Public Comments Received

May 28, 2022

Demonstration that there is a 5 square mile Title 21 65 dB CNEL contour and a 4 square mile Part 150 contour

Figure 3 Comparison of Title 21 and Part 150 65 dB CNEL contours

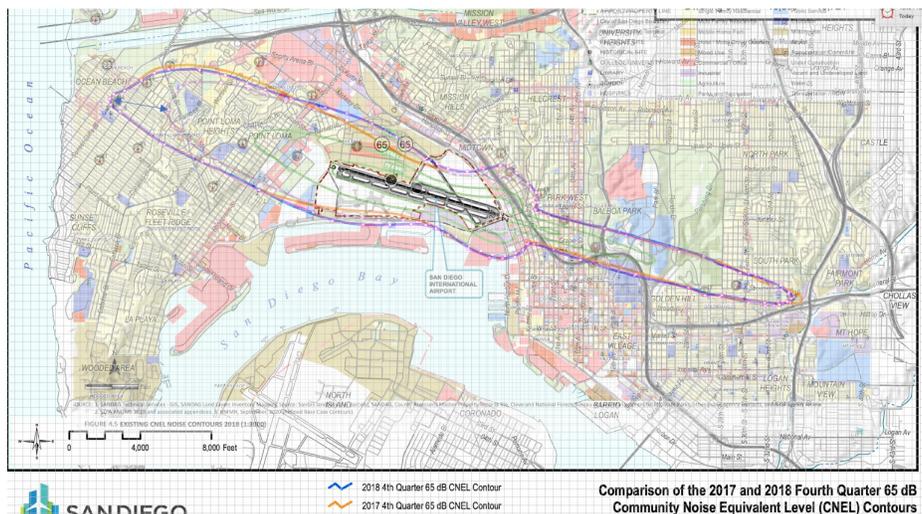
The two contours are shown superimposed in Figure 1. The outside contour is for Title 21. The double arrow line points to the peaks of the two contours. Note also that the contours on the arrival side are nearly identical. The one square mile difference is all on the departure side. We can conclude that the manipulation of data is likely on the departure side of the equation.

It is not just a matter that the two contours are different sizes. What matters is that Kimberly Becker, the CEO in 2021, signed off on both the Title 21 report that went to the State of California and the Part 150 document that went to the FAA. If there is no viable explanation for the difference, then this is misrepresentation, which would represent a clear ethics violation at the least.

Putting this into perspective, if the Part 150 65 dB CNEL contour is only four square miles, and this point was not disputed in an email to me from an Airport Authority Director, then the projected 2026 contour that is used to determine QHP eligibility is also artificially too small. This translates to a more serious violation because it involves holding back dollars for residents who should be eligible for the QHP. I don't believe that this is the only reason for a four square mile contour.

Figure 2 Comparison of slopes of lines connecting contour areas for 2018 and 2026

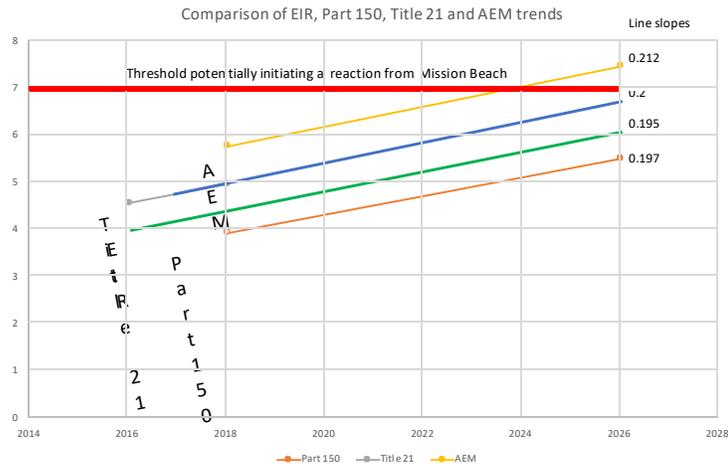
AEM, Area Equivalent Method, is a FAA tool for preliminary screening. I calculated this line by inputting all of the operations by aircraft type into the code for 2018 and 2026 (Part 150 data)¹. It is likely that the contour for this case is too large because the dispersion to the two departures, ZZOOO and PADRZ, is not taken into consideration, which would reduce the peak value. Note that the line slopes for all four cases are almost the same.

The 2026 value for the EIR and the Part 150 were obtained using the contours from the published documents, while the 2026 value for the Title 21 line was extrapolated. Comparing a four square mile versus a five square mile establishes the end points with the Part 150 2026 value at about 5.5 square miles and the Title 21 at about 6.7 square miles. Seven square miles is 27 percent larger than the Airport Authority doctored 2026 contour area, while the seven square miles is only 16 percent larger than the estimated Title 21 2026 contour area.

Figure 5 Part 150 2018 noise contour showing areas how noise monitors would adjust or refine the contour

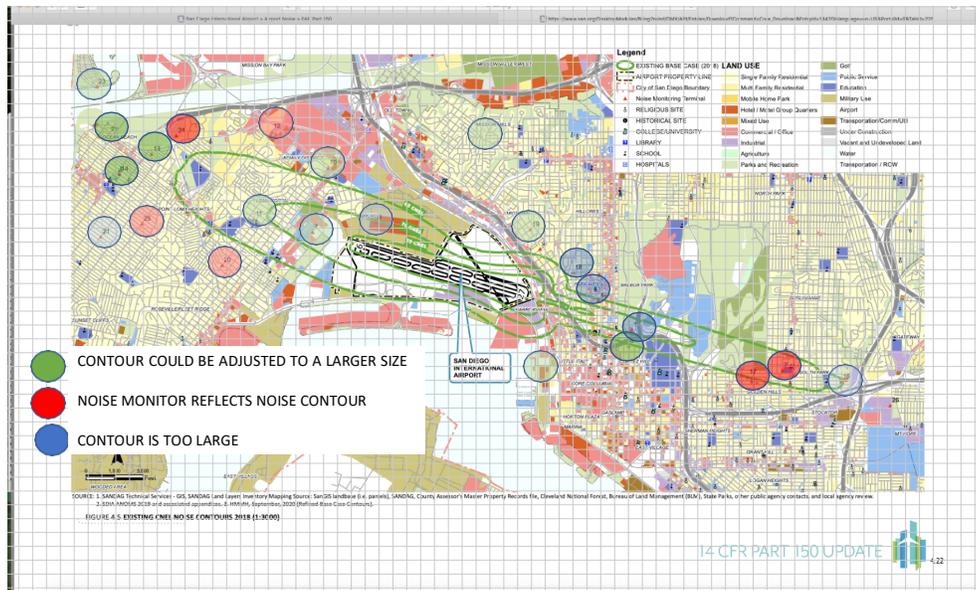
When the senior engineering students used the methodology developed in the last academic year, we found disparities with the Part 150 four square mile contour. The areas where the 65 dB CNEL contour was found to be too small are shown by green circles. Of additional concern is that many of the low areas are on the departure side towards Mission Beach.

Based on the discussion above, I have rejected the response from the Airport Authority Director. I continue to contend that there was no refinement of the Title 21 contour data using noise monitors. I therefore believe that the Part 150 Study 65 dB CNEL contour data was manipulated intentionally to achieve a four square mile 65 dB contour area. The final question is how was this done?

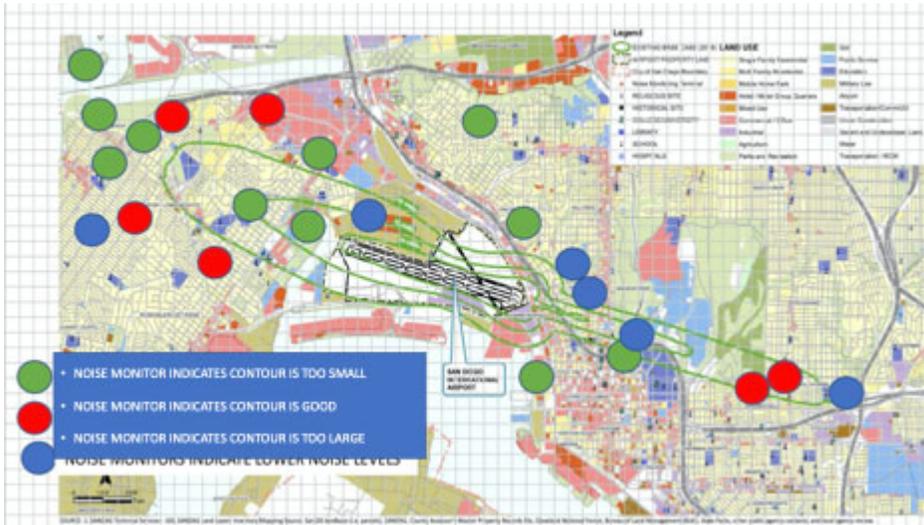
In the picture below, I have color coded the noise monitors indicating which ones indicate that the AEDT model is understating the contour size. The picture below is from the SDIA Title 21 Q4 2018 report. The green dots are where the noise monitors indicate that the contour is too small. I made this assessment using the following approach:

- 1) I calculated the CNEL noise level for each of the NMS noise monitors using the AEDT generated contour.
- 2) I compared the annual noise monitor CNEL value with the analytically generated value for the noise monitor location.
- 3) I then calculated the effective 65 CNEL area in square miles for each of the NM locations, and finally
- 4) I averaged the areas for all of the NMS locations to come up with an integrated average 65 dB CNEL area.

There clearly are trends that can be seen from the analysis. The contour is seen to be too small for the area that veers off to the right towards Mission Beach. It is crucial to be able to visualize this in the Title 21 report to the State. To accomplish this, I propose that the Airport Authority be required to add CNEL values at TBD grid points. I also believe that these grid CNEL values should be included in a table so that they might be used for making the contour assessment. I also believe that the Airport Authority should from this time forward be required to adjust the AEDT contours using the NMS as is stated in the variance.

Comparison of the 2020 and 2021 Fourth Quarter 65 dB Community Noise Equivalent Level (CNEL) Contours

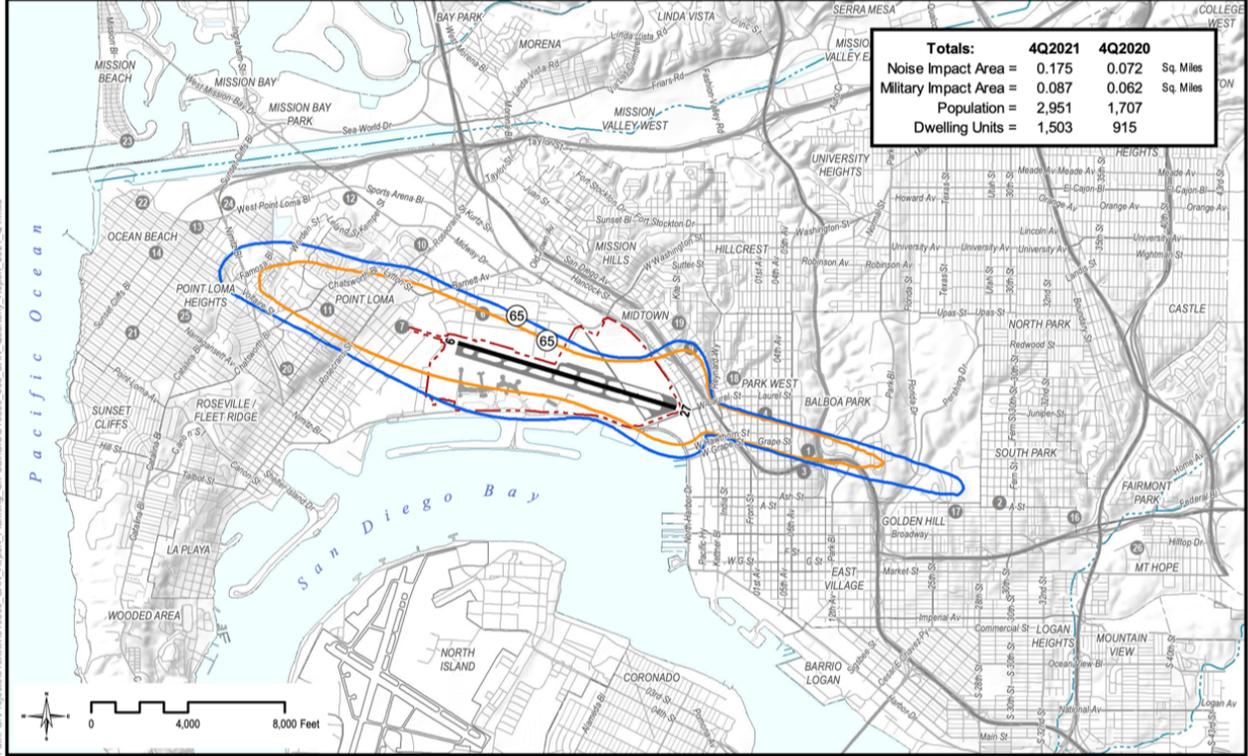
Unless the State is getting information not included in the quarterly Title 21 reports, I don't see that the Airport Authority is complying with the provision below, providing multiple contours. I believe it is important for all of these to be provided. I know that the residents outside of the 65 could have benefitted over the years to see how the 60 was changing, for example. And, I also believe that those in the 70 dB CNEL might have gained greater insight into their noise disruptions and potentially a contour that is too small compared to the NMS. The grid values will help here.

11 | 3. The Airport Authority's annual report (for each calendar year) shall plot the annual
 12 | CNEL contours for the 60, 65, 70, 75, and 80 dB CNEL noise contour levels (as developed and
 13 | reported by the Airport Authority) and shall quantify the areas of incompatible land use.
